Joint written submission from the Canadian Environmental Law Association, Concerned Citizens of Renfrew County and Area, Nuclear Waste Watch, and Northwatch

**Canadian Nuclear Laboratories,
Douglas Point Waste Facility**

Application to amend the waste facility decommissioning licence for the Douglas Point Waste Facility

**RE: PROPOSED DECOMMISSIONING LICENCE AMENDMENT - COMMENTS ON
CANADIAN NUCLEAR LABORATORIES LTD. (“CNL”) DECOMMISSIONING
LICENCE AMENDMENT APPLICATION FOR THE DOUGLAS POINT WASTE
FACILITY**

Figure 1: Proposed new DPWF Decommissioning Timeline, reproduced from CNL’s webpage for Douglas Point [11]

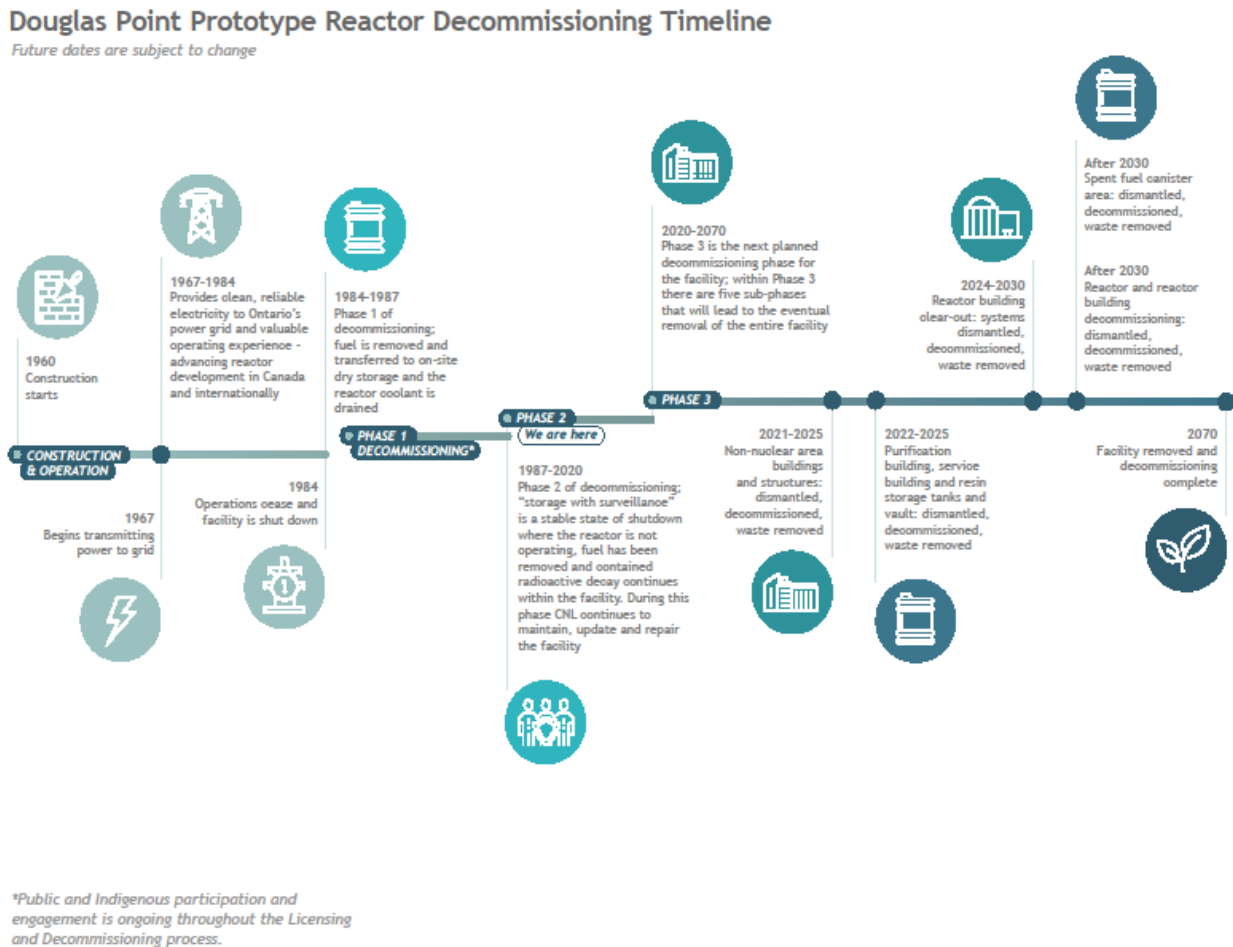
CNL’s proposed DPWF decommissioning timeline is depicted in **Figure 1** below. The timeline ends with the five proposed Phase3 decommissioning planning envelopes/sub-phases on the right.

CNSC’s Regulatory Guide G-219 (Decommissioning Planning for Licenced Activities), Sections 6 (“Structure and Content of Decommissioning Plans”) expects a detailed decommissioning plan (DDP) “normally to be a refinement and procedural “fleshing out” of the work package structure established in the PDP” [10]. DDP1, however, clearly marks a significant strategic departure from the PDP [emphasis is the author’s]. Although one would expect such an unusual departure of a DDP to be explained and justified carefully and in detail, it is remarkable that the DDP1 leaves most of the strategic points of departure unexplained, as will be seen in Section 5.
